Old Globe Way Improvements And Employee Parking Structure Presentation

March 20, 2014

Park and Recreation Board

*Recommend approval of the proposed General
Development Plan for Old Globe Way Improvements*

Parking Structure

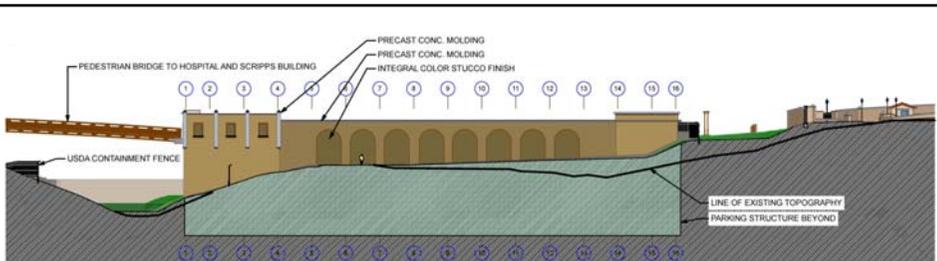
- *The low wall at the garage entry should be deleted from the plan since it doesn't serve a necessary purpose.*
- *Provide a stronger horizontal lintel on the south wall.*

- *Add a horizontal element and more fenestration to the arches on the west wall to lessen the size of the arches.*
- *Explore the use of cast-in-place concrete instead of stucco for the parking structure walls.*

- *To facilitate maintenance, keep landscape materials away from the parking structure walls.*
- *Increase the parking structure mass appearance at the elevator tower in the north elevation.*
- *Keep the potential use of solar panels in mind when specifying and placing trees near the parking structure.*
